APPEAL REF: APP/M1900/W/24/3346607

**Land at the former Hatfield Aerodrome, Hatfield Road, Smallford,
Hertfordshire, AL4 0HP**

Draft Statement of Common Ground between the Appellant and Colney Heath Group – Updated Public Access Strategy and Phasing Plans

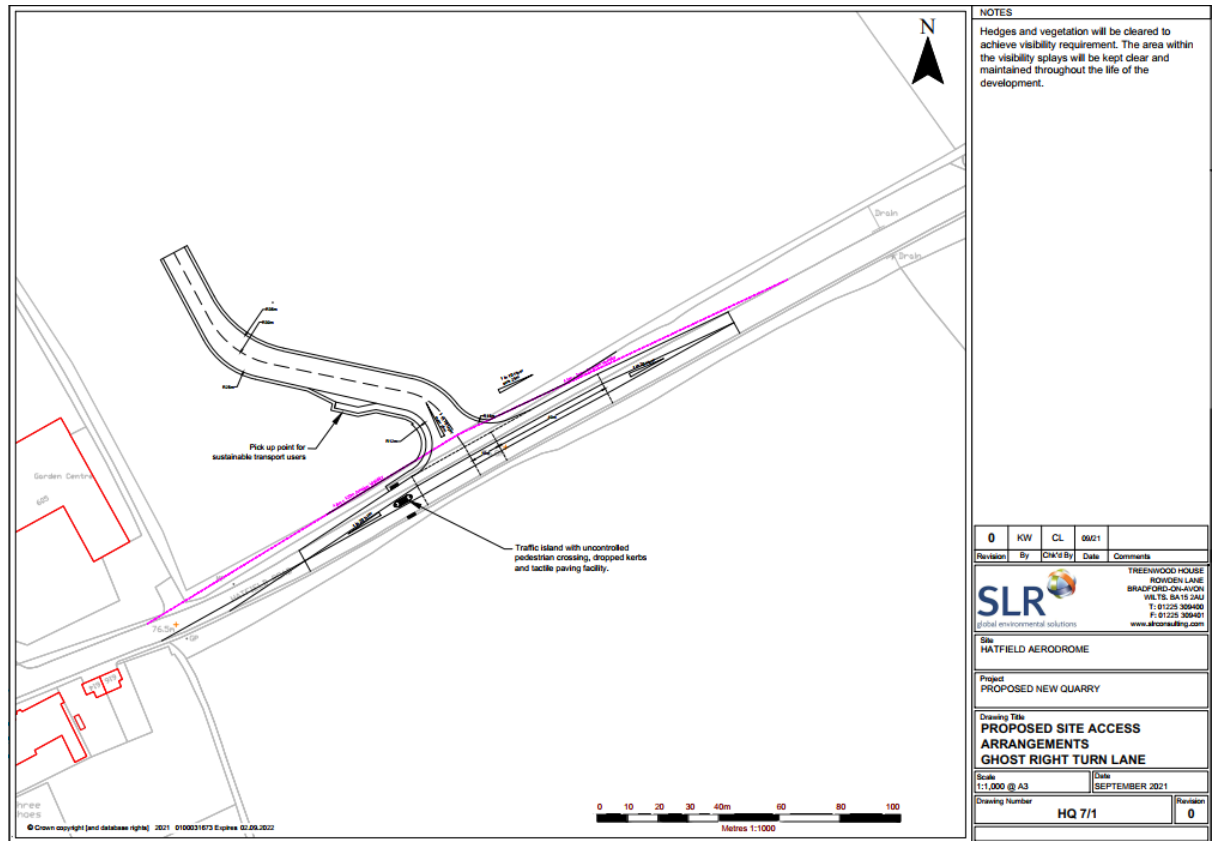
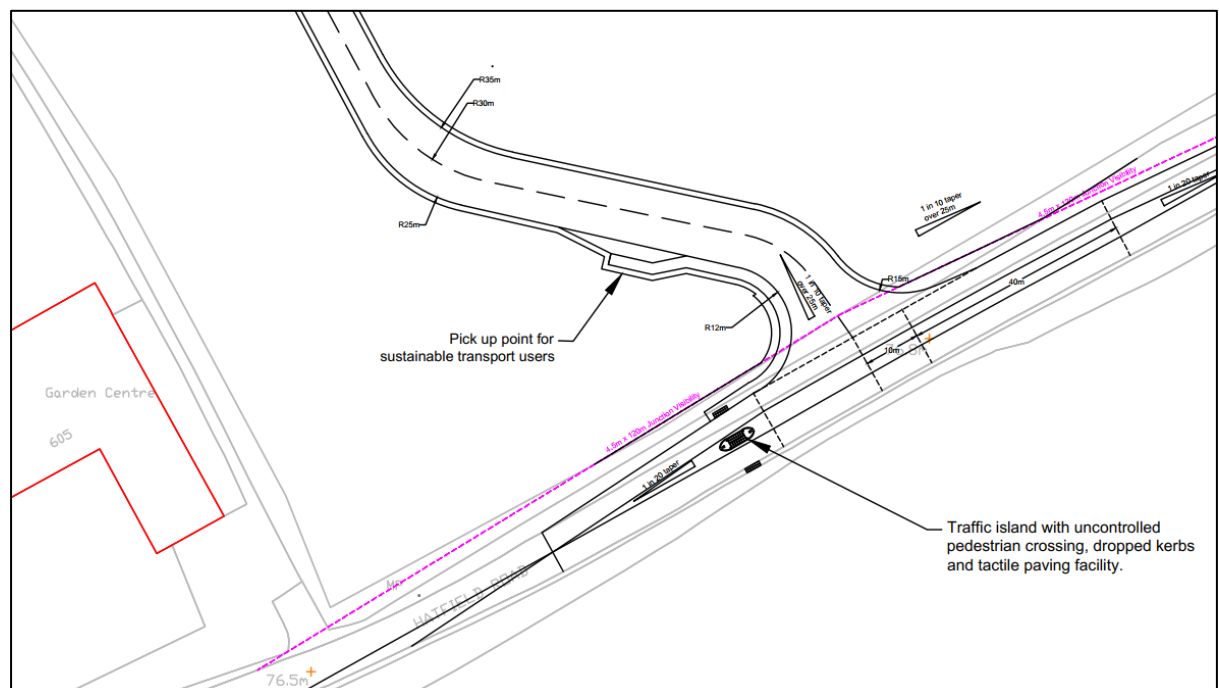
- 2.3.1 The Appellant's plan and the CHG plan show broadly similar alignments of existing paths within the site. **There are many existing paths currently within the site.**
- 2.3.2 ~~The Plans above show that there are currently only two direct access points between the east of Ellenbrook Fields and the west.~~ **CHG dispute this statement and confirm there are three.**
- 2.3.3 ~~The Revised Public Access Strategy (February 2026) shows that the two existing access points connecting the east of the park to the west always remain open throughout the life of the development.~~ **CHG challenge the term open is questionable as they have unfettered access where they will now be blocked or have gates or crossings.**

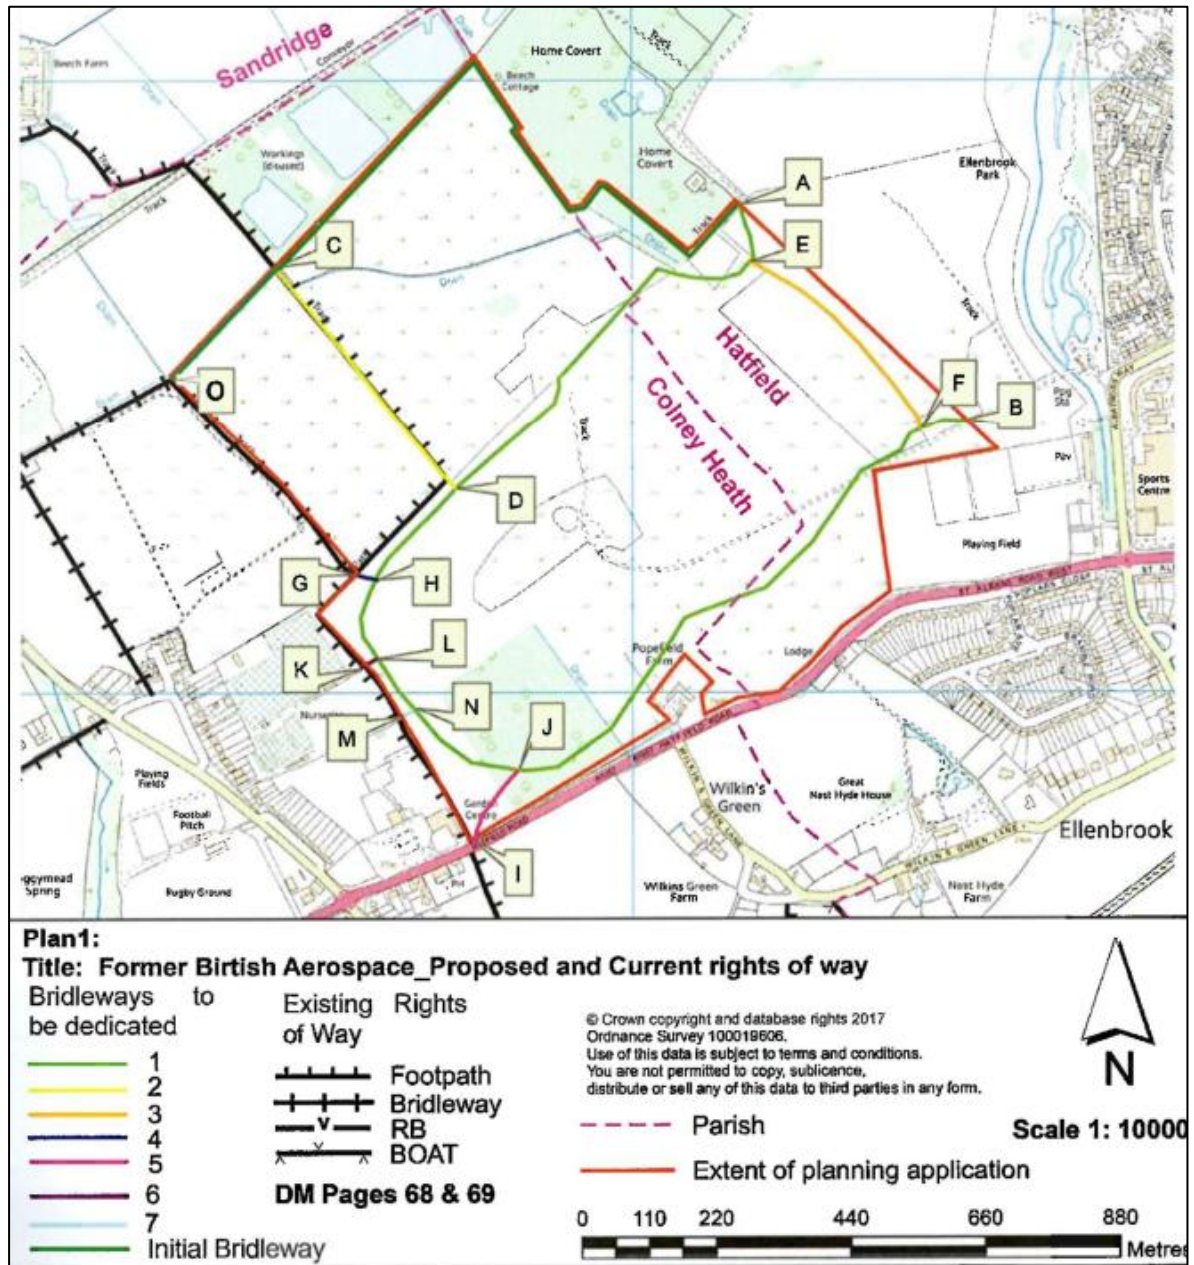
- a series of bridleways to be constructed by the appellant (plan to section 106 agreement dated 19 December 2024 INQ 3.1). **Not requested by CHG therefore not agreed as the group have no experience or knowledge of the requested bridleways**

- Not requested by CHG therefore not agreed as the group have knowledge of the requests.

Lagoons relative to
existing access tracks
(CHG plan)

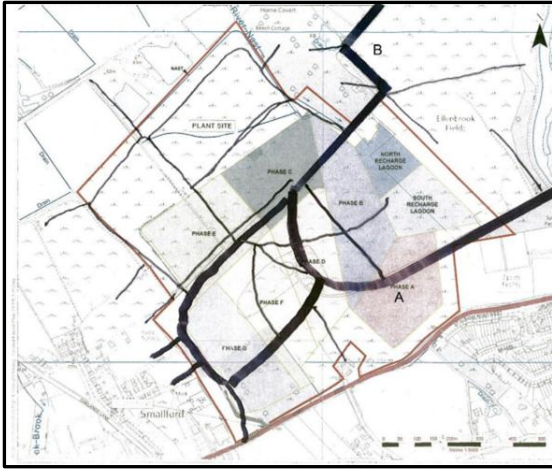
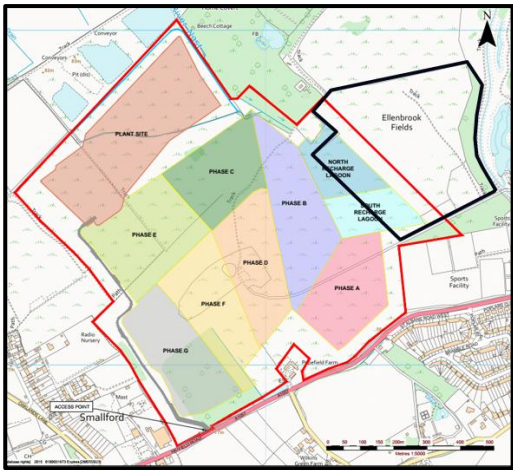
- 4.2.1 ~~The lagoons do not sever or affect any existing formal or informal paths.~~ **Do not agree as no methodology provided**
- 4.2.2 The proposed lagoon area was until recently partly located within a fenced off livestock enclosure.

- 4.2.5 ~~Significant portions of the land to the west of the livestock enclosure, i.e. to the south of fence line, are currently inaccessible due to dense vegetation.~~ **Not agreed this would be a matter for the Trust to manage and/or change.**

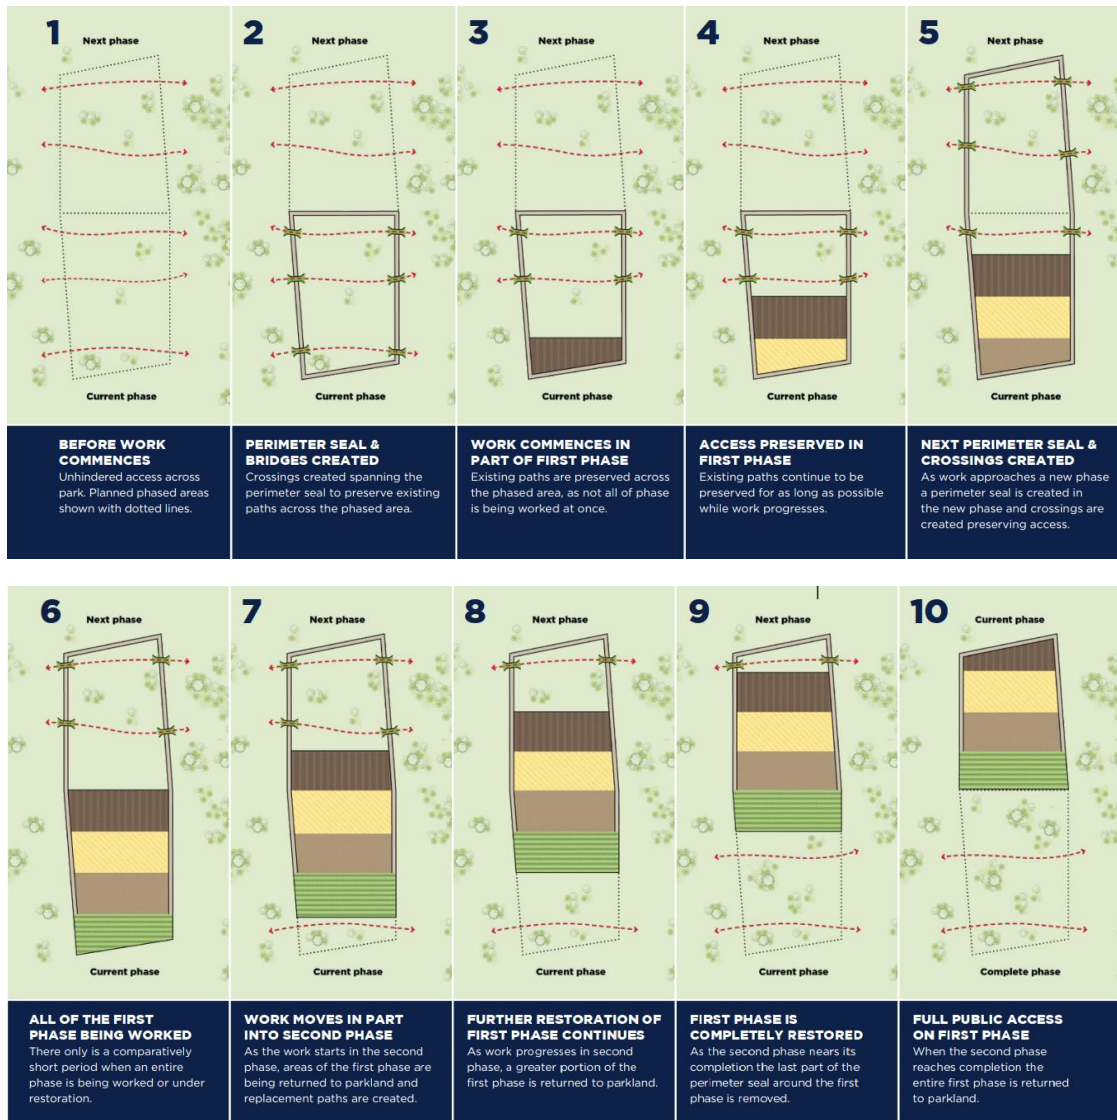
- 6.2.3 ~~Public access is provided on land prior to being worked and on land that has been restored in accordance with the proposed plan.~~ Brett have no control or process to handover small parcels of land beyond condition 27.

- 6.2.4 ~~The area under restoration will be opened to the public as soon as the land is suitably established to allow for public access.~~ Brett have no control or process to handover small parcels of land beyond condition 27.

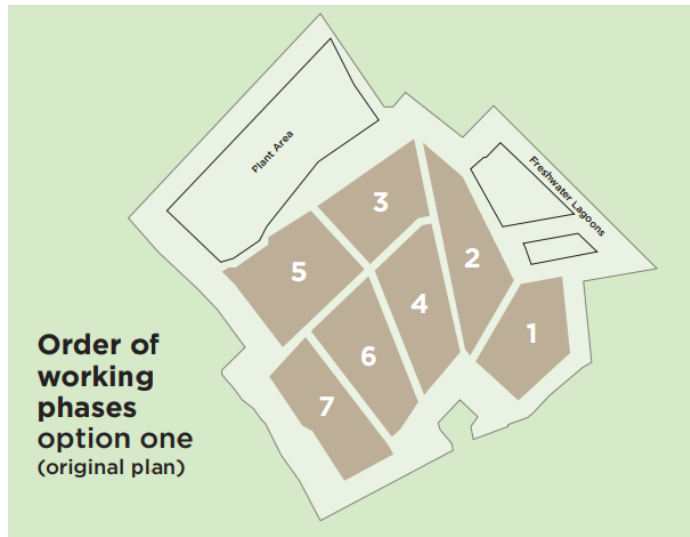
8.1 ~~Alternative Phasing (Option 2)~~ This does not represent the CHG proposal
